JANUARY 27, 2014

PC 14-02

The Village requests text amendments to Section 155.602 (A)(5) and (C), including Figure 6-1, Table 6-2, and any other relevant sections for clarity, of the Village of Lombard Zoning Ordinance.

DESCRIPTION

Figure 6-1

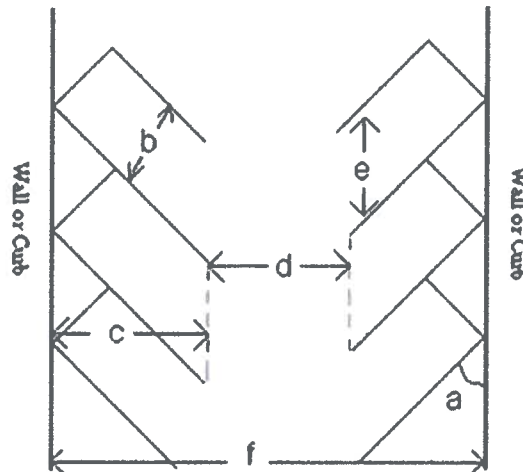
The Fire Department response to staff’s initial proposed dimensions expressed a concern regarding insufficient drive aisle width to accommodate safe navigation and setup of Fire Department apparatus.

Private Engineering Services provided the following comments in response to staff’s initial proposed dimensions:

1. The aisle widths are really narrow as shown.

- a. 1990 ITE standards show that one-way forty-five degree (45°) parking should have a minimum fifteen foot (15') wide drive aisle, one-way sixty degree (60°) parking should have a minimum eighteen foot (18') wide drive aisle, and ninety degree (90°) parking should have a twenty-six foot (26') wide drive aisle. It is PES' opinion that the proposed drive aisles are too narrow.
 - b. If a vehicle breaks down, there is no available width for another vehicle to pass. PES proposes the existing aisle width standards be left as are. This could also be an issue for the fire department in regards to a possible vehicle fire and needing to get a fire truck through the aisles.
2. If using a two-way drive aisle, the sixty degree (60°) dimensions should be as the same as for two-way ninety degree (90°) parking.

All off-street parking spaces hereinafter required by this ordinance, except those required for one and two family dwellings, shall be designed in accordance with one of the formulae set forth in Figure 6-1 and

The proposed text amendments were then revised by staff to address the Fire Departments concerns. The proposed drive aisle for sixty degree (60°) and forty-five degree (45°) parking is now two feet (2’) wider than the Fire Department’s minimum request.

Planning staff addressed all of PES' comments and concerns in the revised text amendments that are currently proposed.
